Product Change Notification / SYST-19GWSQ227

ERRATA - SAM D10 Series Family Silicon Errata and Data Sheet Clarifications

SAM D10 Series Family Silicon Errata and Data Sheet Clarification

FIGURE 34-2 and 39-2: POR OPERATING PRINCIPLE:

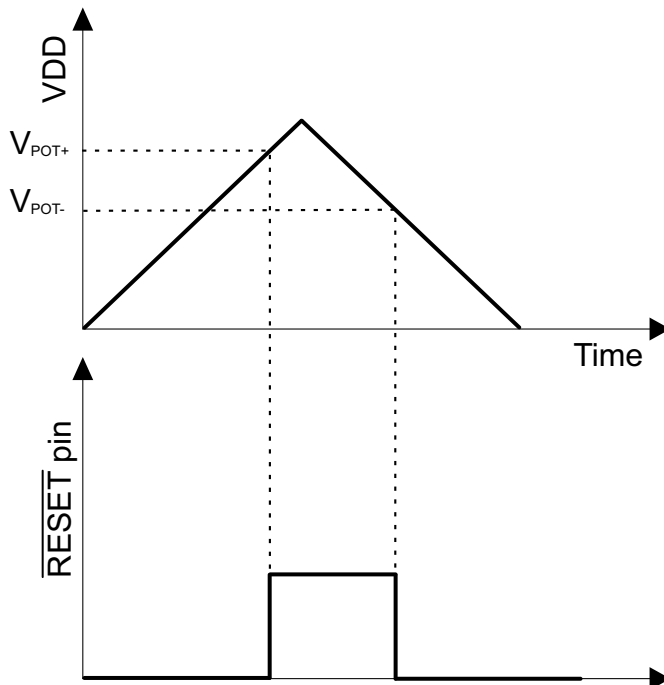
Figures 34-2, 34-3, 34-4, 39-2, 39-3 and 39-4 have an incorrect reset Polarity value. The corrected figures are as shown below:
